## **ADDENDUM NO. 01, AUGUST 19, 2022**

RE: Brighton Beach Resiliency Plan – Shoreline Restoration Work: Phase I

LHB Project No. 210260

**C003**

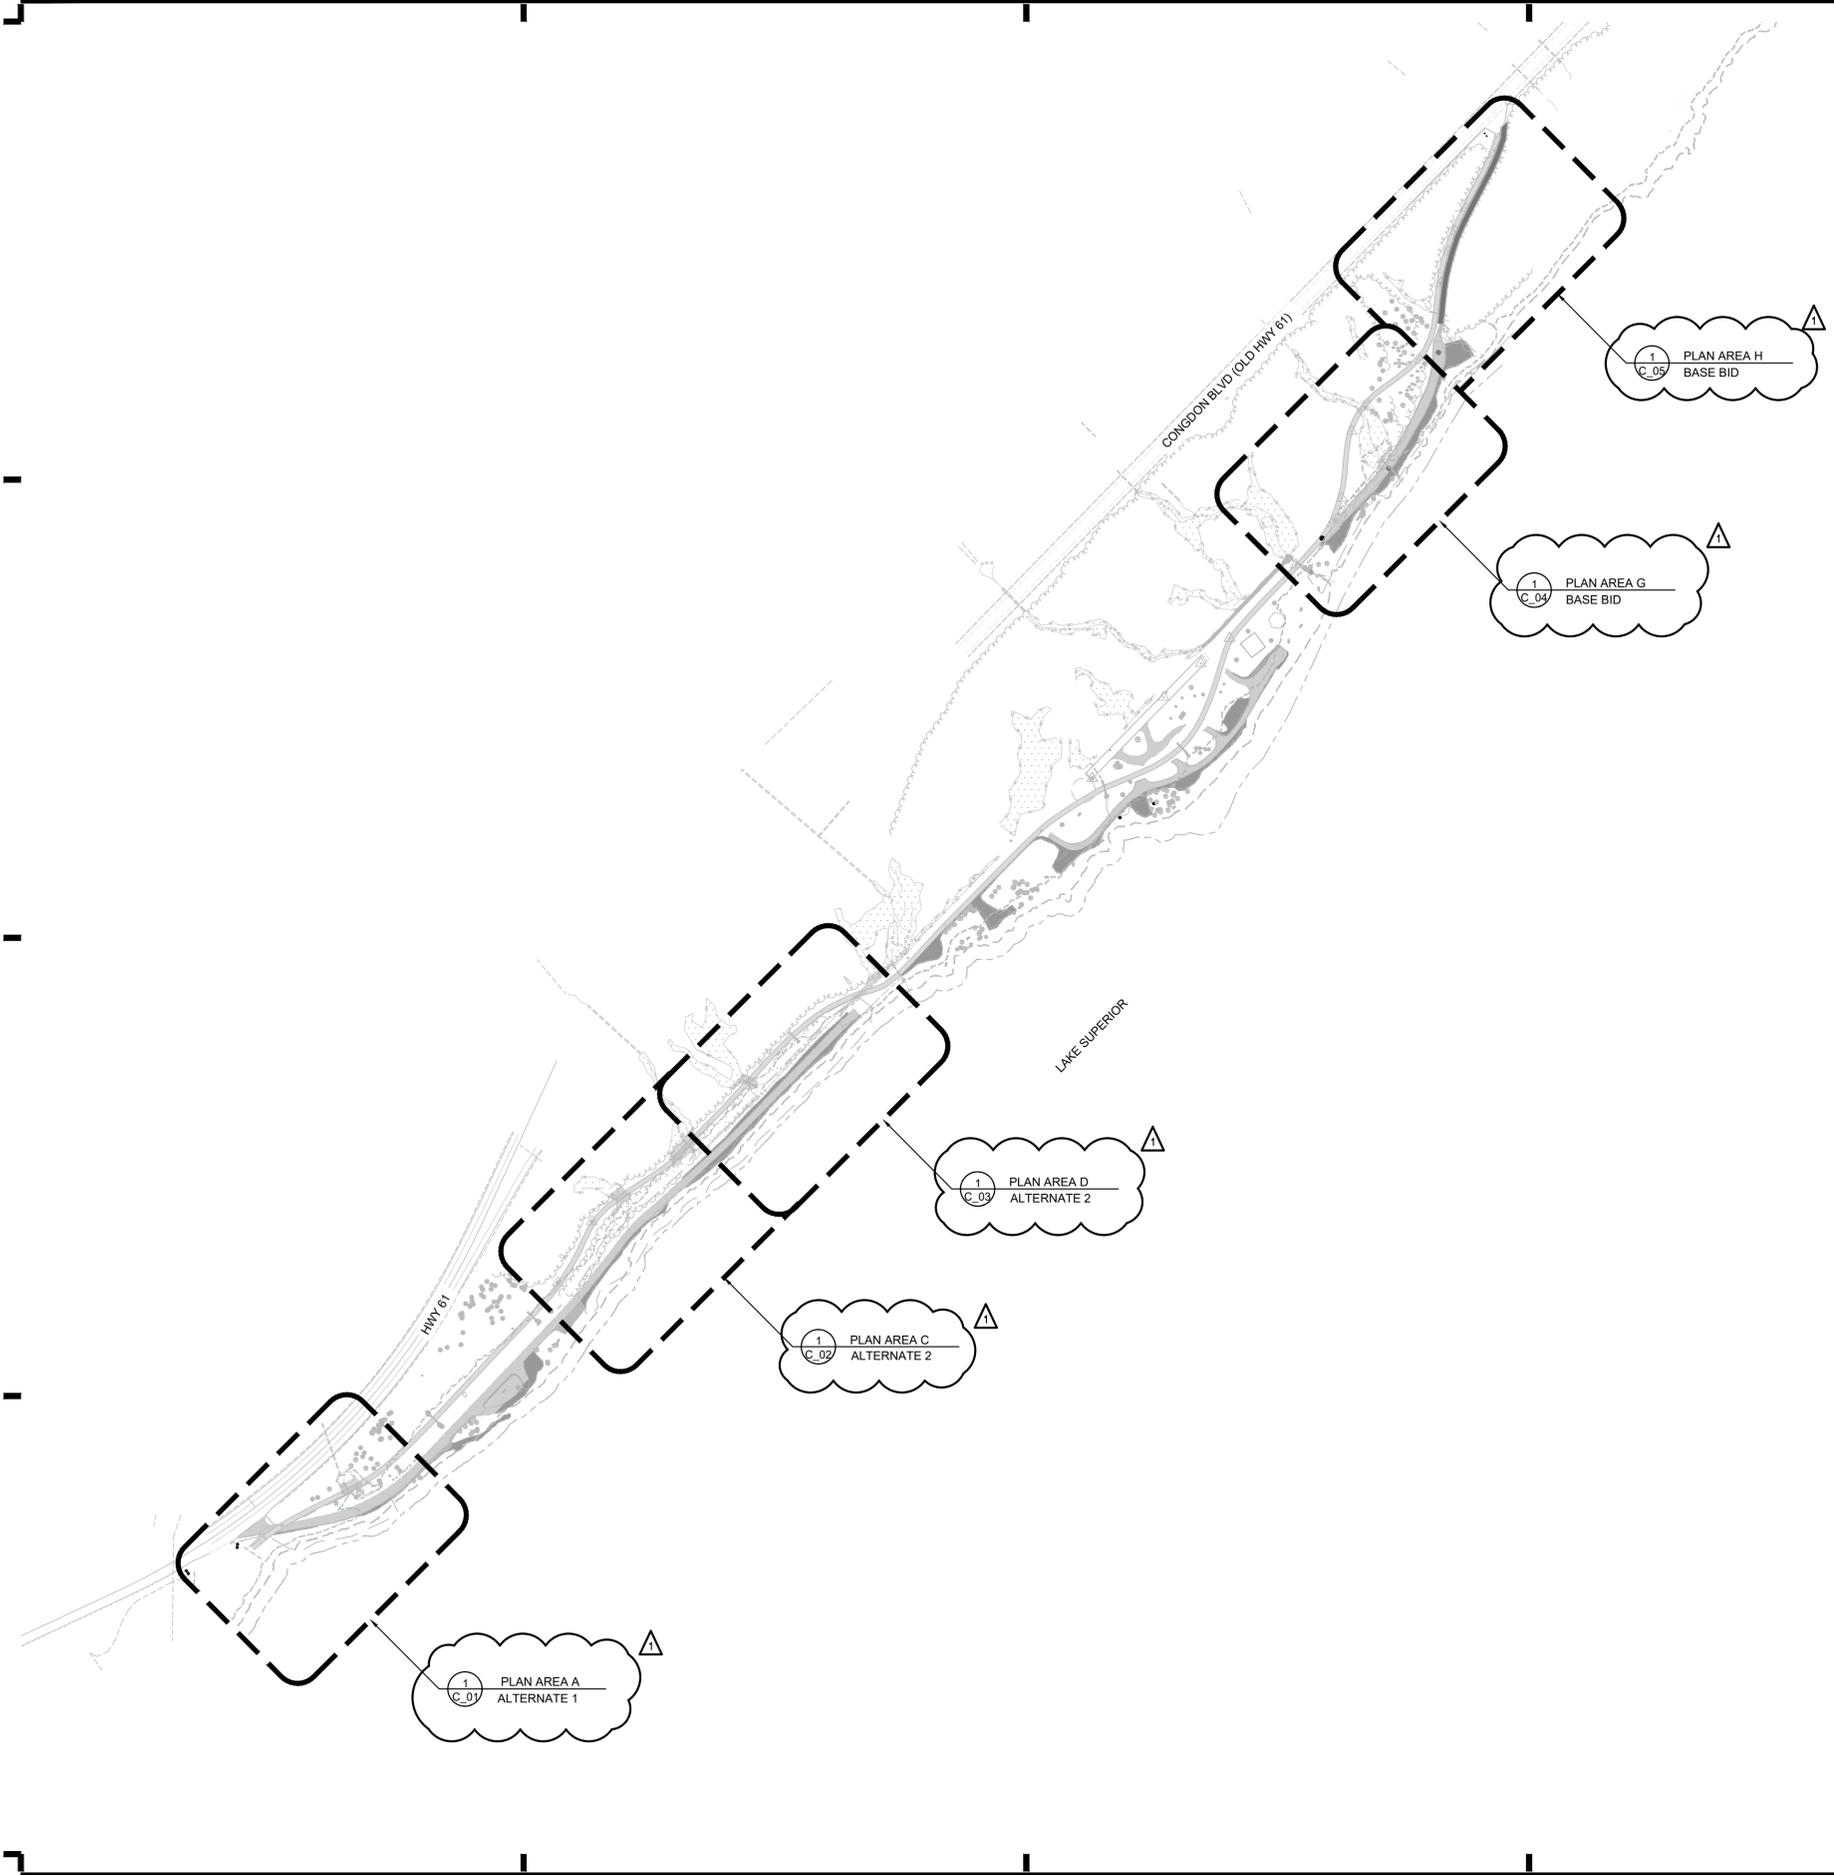
1. Clarification: Modifications to the Bidding Structure have been made to the Drawings. Instead of four (4) Bid Areas, there is now one (1) Base Bid Area and two (2) Alternate Areas.
2. The Bid Form has been replaced in Bid Express.

- A. Alternate No. 1 - Area A: Provide and install all work associated with shoreline restoration work in Area A including removals, erosion control, grading and drainage, site restoration and vegetation re-establishment.
  - 1. Alternate Item: See all Sections and Drawing numbers C003, C101, C301 and C401 for scope of work and location.

- B. Alternate No. 2 - Areas C & D: Provide and install all work associated with shoreline restoration work in Areas C & D including removals, erosion control, grading and drainage, site restoration and vegetation re-establishment.
  - 1. Alternate Item: See all Sections and Drawing numbers C003, C102, C103, C302, C303, C402, and C403 for scope of work and locations.
